CITY OF ALBUQUERQUE

RE: 4913 Regina Circle NW
Revised Grading and Drainage Plan
Engineer's Stamp Date: 11/30/20
Engineer's Certification Date: 04/16/21
Hydrology File: J11D041

Renée C. Brissette, P.E. CFM
Senior Engineer, Hydrology
Planning Department

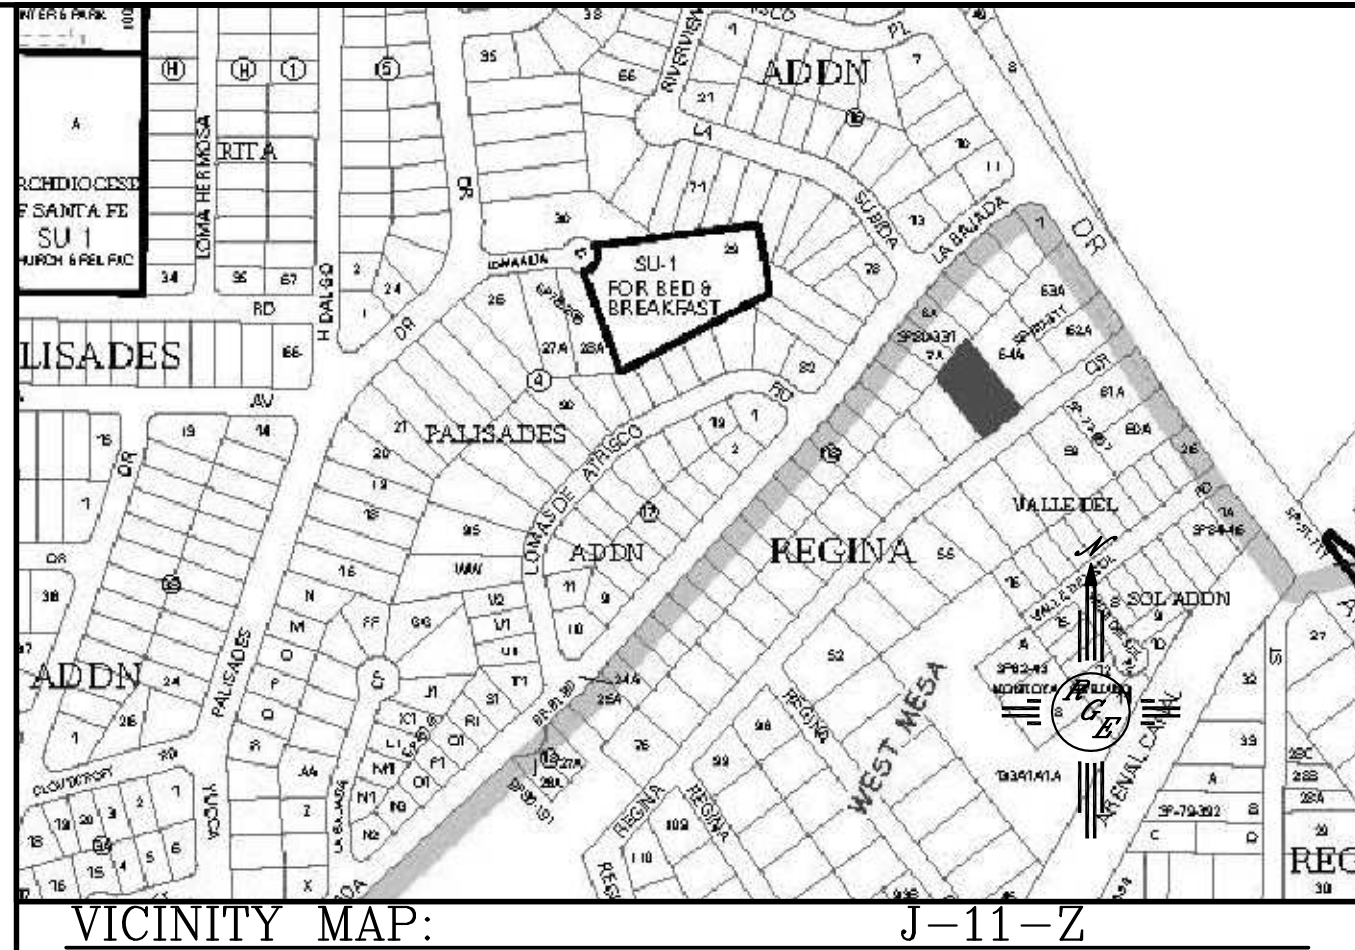
Based upon the information provided in your submittal received 04/16/2021 and site photos sent on 04/16/21, the Grading and Drainage Plan is approved for Building Permit and Building Pad Certification for 4913 Regina Circle NW. Please attach a copy of this approved plan in the construction sets for Building Permit processing along with a copy of this letter.

Prior to approval in support of Permanent Release of Occupancy by Hydrology, Engineer Certification per the DPM checklist will be required.
